FINAL FINDINGS AND DECISION BY THE DESIGN **COMMISSION RENDERED ON May 4, 2017**

CASE FILE NUMBER: LU 16-273094 DZM AD
PC # 16-128329
The Press Blocks

16TH AVE RESIDENTIAL BUILDING | NORTH & SOUTH ELEVATIONS

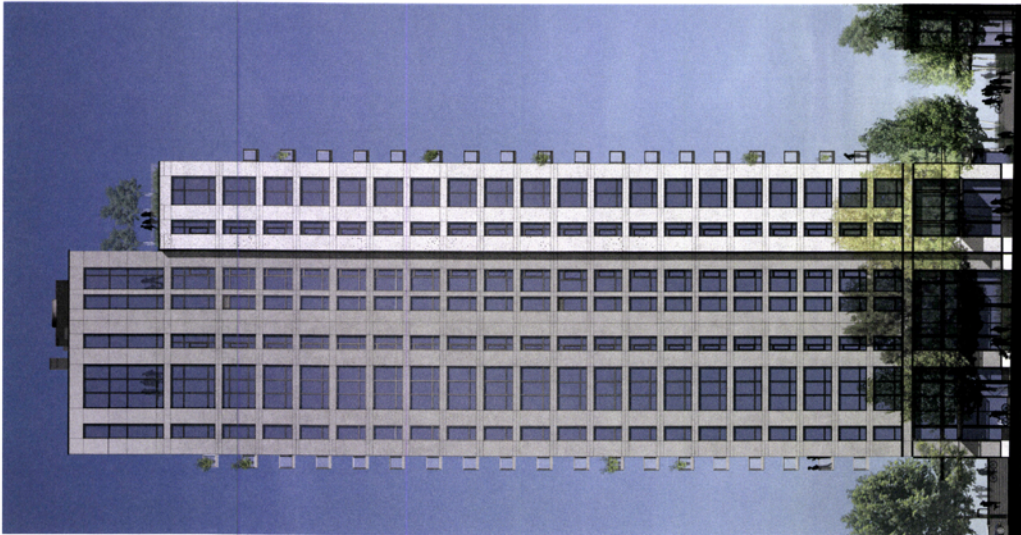
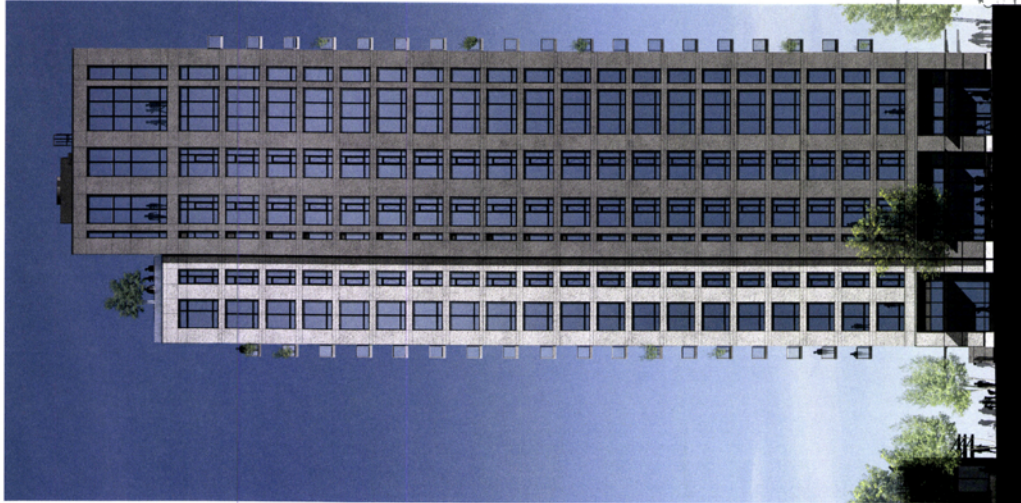
In response to Design Commission comments at the March 23, 2017 hearing regarding the office-like appearance of the north and south elevations, the design has been revised to feature a more residentially resolved punched window expression.
